HISTORIC PRESERVATION BOARD

HISTORIC PRESERVATION BOARD MEETING

The Historic Preservation Board will hold a remote meeting on August 5, 2020 at 5:00 p.m. This meeting will take place using Zoom.

- i. Certificate of Appropriateness for Exterior and Site Alterations; 130 R PARK STREET; Lori Price, Applicant.
- ii. Certificate of Appropriateness for New Construction, including Site Improvements; 34 SPRUCE STREET; Tim Gebhardt, Applicant.
- iii. Certificate of Appropriateness for Site Alterations; EASTERN PROMENADE HISTORIC LANDSCAPE DISTRICT; Department of Parks & Recreation, Applicant.

PROPOSED LANDSCAPE PLAN RENDERING

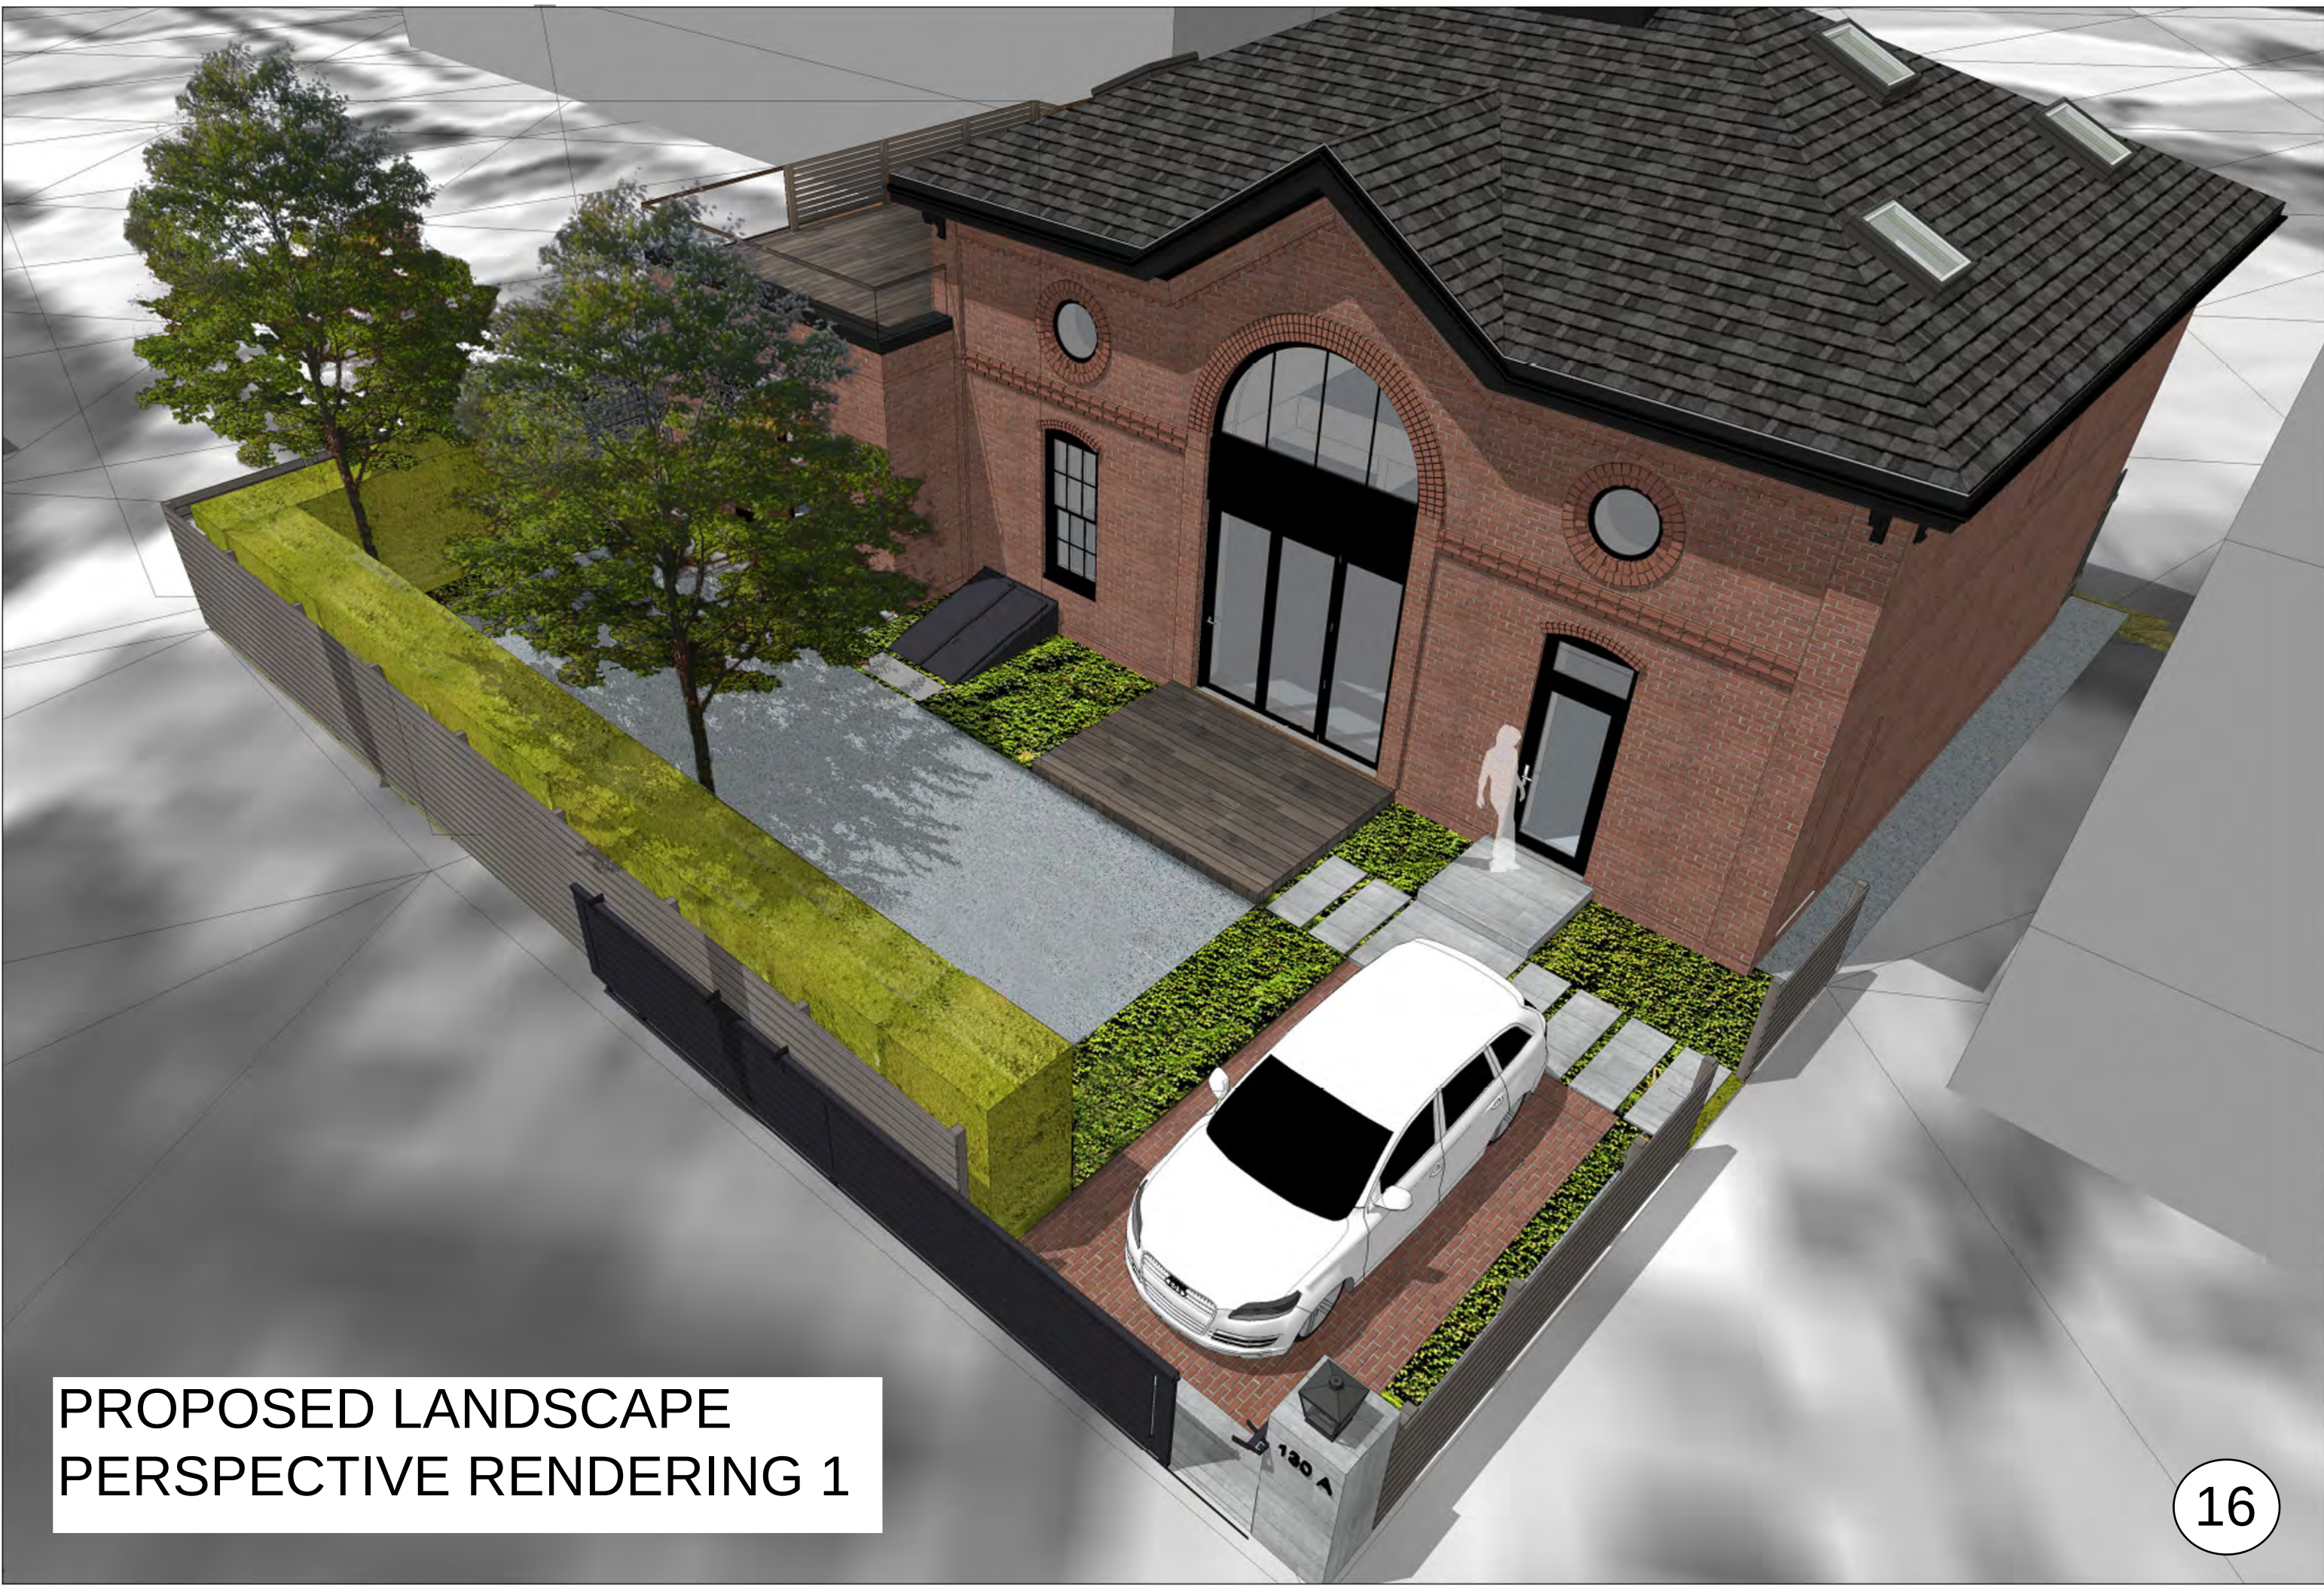
- The site treatment at the southeast corner was discussed extensively; several Board members articulated that the approach to the carriage house needed to be more open and visible. Although the desire for some security and privacy was acknowledged, the Board thought a more open design would be important to convey the original utilitarian use of the building – a carriage house that was entered frequently by vehicles and people. Though supportive of the adaptive reuse, members thought this aspect of the building was a character-defining-feature. Details of the site plan discussed included:

- Board members' desire for greater openness, simplicity, and fewer materials
 - The large granite pier anchoring the southeast corner was not supported by the Board; it was thought to be too heavy, solid, and an unnecessary use of an additional material, out of character with the rest of the plan.

- The light mounted to the top of the granite pier was not supported either, as it had a falsely historic appearance.
 - On the north face, Board members were not supportive of the proposed arborvitae trees at the base of the north wall. They noted that the north wall is the only original façade to be left unchanged, and its open view should not be obscured. It was suggested that low, ground-level plantings could be used to soften the base, without hiding the wall.

- Low perennial plantings will be installed along the north property line, instead of arborvitae.
- The hedge in the southern yard has been pulled back in line with the edge of the carriage house door.
- We will replace the southeast corner fencing with a high visibility, black metal fence. Fencing consists of 2"x1/2"x4' tall steel fins. Bar stock will be welded 4" o.c. to linear base plate below grade, and anchored to frost depth sono-tubes.
- Cantilevered auto gate will be made of the same fencing material, and will now slip behind new slatted fence.
- Granite post at southeast corner of yard has been removed and the autogate will now terminate into a 2"x6" steel corner post (painted black).

EXISTING VIEW:
 FAR VIEW NORTHEAST CORNER OF
 PARKING LOT AT PARK STREET. SOME
 VISIBILITY OF NORTHERN MOST SKYLIGHT.

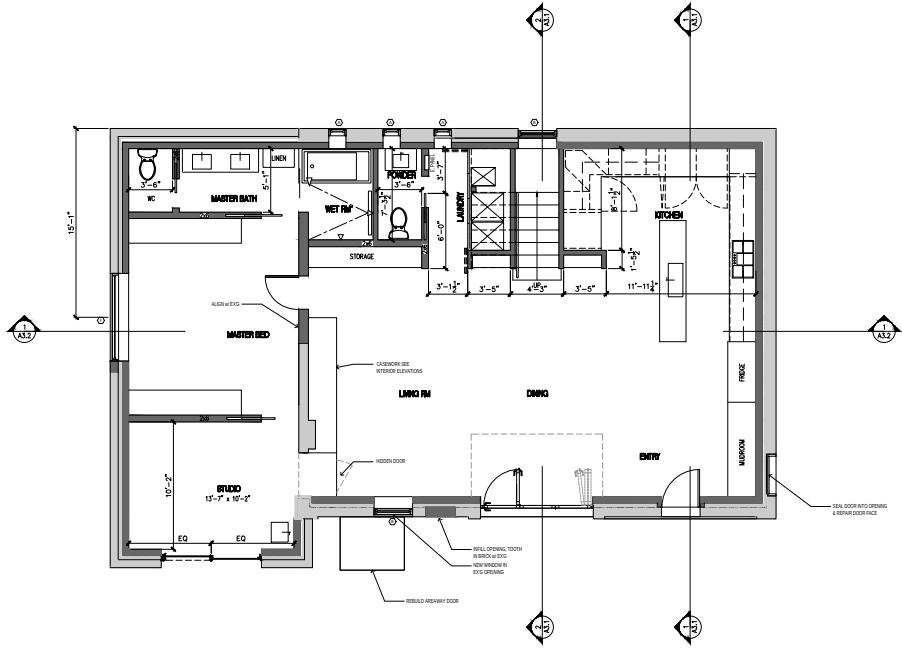
- Board members may still have reservations about the three proposed skylights in the east roof. (The northernmost one has been moved south by 12" to be less visible.) Given that two will be visible at a distance from the north on Park Street, operable skylights are not an intervention to be taken lightly. But with this adaptive reuse of the carriage house, perhaps a pristine view is going to prove difficult; limitations on adding other openings make it a challenge to add light and air to the east bedrooms.

PROPOSAL:
 MAINTAIN PROVISION FOR OPERABLE
 SKYLIGHTS ON EAST ELEVATION FOR LIGHT
 AND VENTILATION. NORTHERN SKYLIGHT
 MOVED SOUTH 12" TO MINIMIZE VISIBILITY.
